### **Response to comments from Reviewer #3**

This paper intends to provide a documentation for the latest version of the high-resolution Beijing Climate Center Climate System model (BCC-CSM2-HR). It consists of a succinct overview of what are new in each of the model components and an evaluation of the model performance using a broad set of climate metrics. The evaluation of the BCC-CSM2-HR is presented in parallel with that from a medium resolution model, BCC-CSM2-MR, which differs from the HR model not only in resolution, but also in core components. Improvements of the HR over MR are highlighted throughout the text. BCC-CSM2-MR is used to participate in CMIP6, while BCC-CSM2-HR participating in HiResMIP. The materials presented regarding the models and the simulation skills are expected to be useful for the users of the models and/or the simulated data, and thus suitable for a publication on GMD as an essential reference.

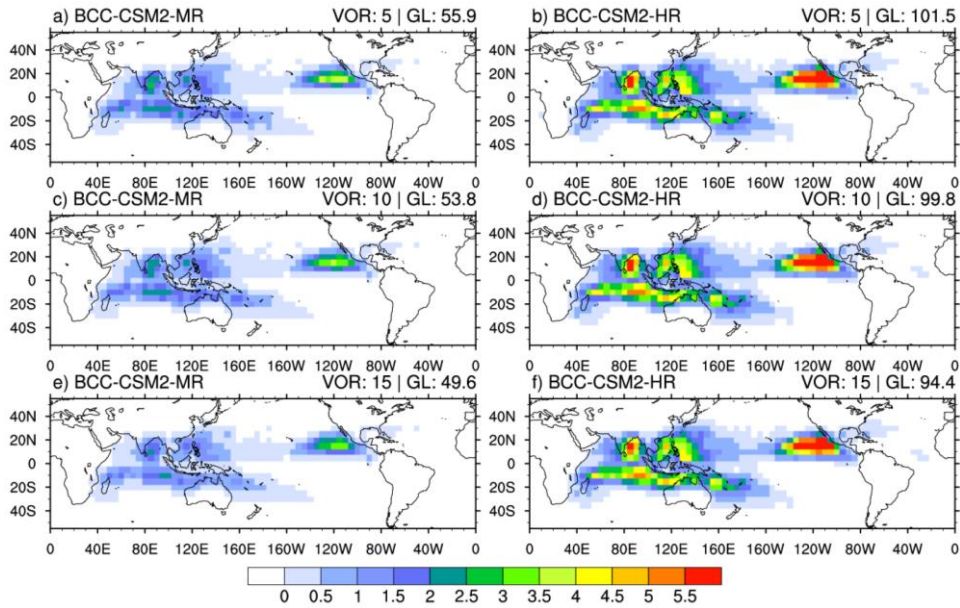
Paragraph starting line 542, TC criteria, please explain why using a relative vorticity criterion differing by 15 times for the HR and MR models, how sensitive are the results to this criterion and how it impacts the interpretation of the derived results.

*Response: In the first version of the manuscript, the threshold of relative vorticity at 850 hPa to detect TC for BCC-CSM2-MR and BCC-CSM2-HR were wrongly set to different values, which created difficulties for our purpose of inter-comparison, although that practice was perfectly valid to detect TC in individual models. We unified now the threshold (to a unique value of  $15 \times 10^{-5} s^{-1}$  in Figure 14). We also added some discussions on the influence of different thresholds: “If this threshold gets looser to  $5 \times 10^{-5} s^{-1}$ , the averaged total global TC numbers per year in BCC-CSM2-MR and BCC-CSM2-HR will enhance to 55.9 and 101.1, respectively” in line 684-686. The following figure shows the global distribution, but omitted in the main text of the revised manuscript.*
